SHEARON HARRIS NUCLEAR POWER PLANT, UNIT NO. 1
DOCKET NO. 50-400/LICENSE NO. NPF-63
CYCLE 15 CORE OPERATING LIMITS REPORT

SHEARON HARRIS NUCLEAR POWER PLANT
DOCKET NO. 50-400/LICENSE NO. NPF-63
CYCLE 15 CORE OPERATING LIMITS REPORT

SUMMARY OF CYCLE 15 COLR REVISIONS

Harris Unit 1 Cycle 15
Core Operating Limits Report - Rev. 0

Figure 4
K(Z) - Local Axial Penalty Function for $F_Q(Z)$

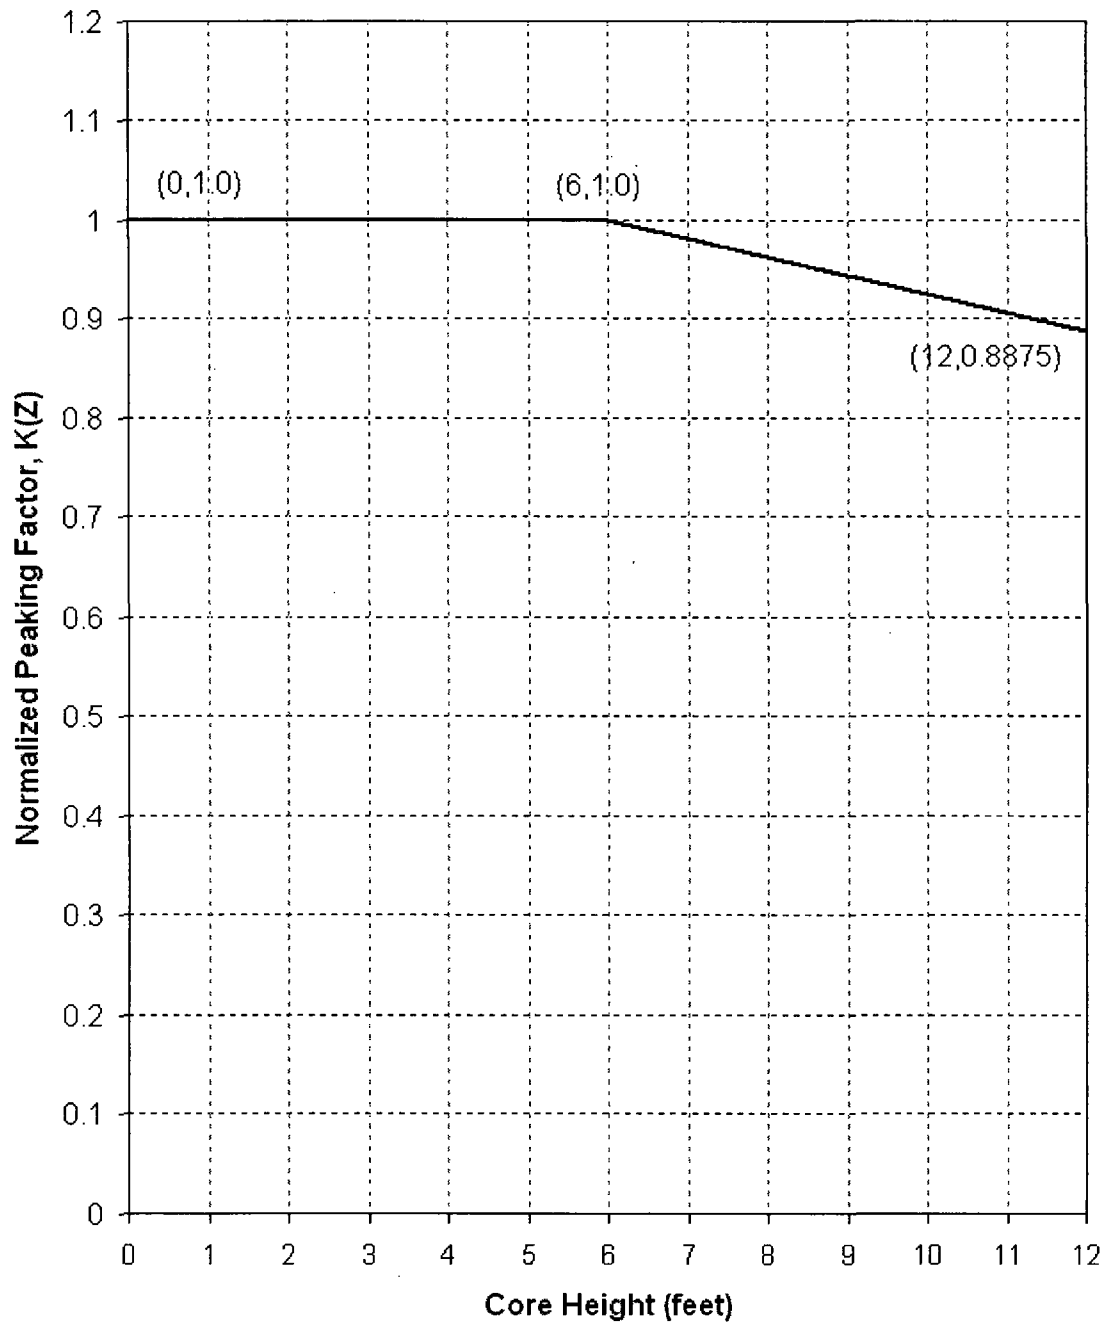
<u>Section</u>	<u>Description of Change</u>
	Cycle 14, Rev. 1 was revised to Cycle 15, Rev. 0 throughout the document.
2.2.2	The 300 ppm/ARO/RTP MTC limit was updated from -42.5 pcm/°F to -42.0 pcm/°F.
2.4	The Control Rod Insertion Limit fully withdrawn for all control rods was updated from 228 steps to greater than or equal to 225 steps.
2.6.2 and Figures 5-8	Change in V(Z) curves and applicability ranges.
2.7.b	Fdh limit changed from 1.64 to 1.66.
2.8	Refueling water boron concentration updated to 2172 ppm.
Figure 1	Updated Shutdown Margin vs RCS Boron Curve.
Figure 2	The Control Rod Insertion Limit fully withdrawn for all control rods was updated from 228 steps to 225 steps.
Figure 3	Updated Axial Flux Difference as a Function of Thermal Power Curve.
Figure 4	Updated K(Z) – Local Axial Penalty Function for F _Q (Z) Curve.
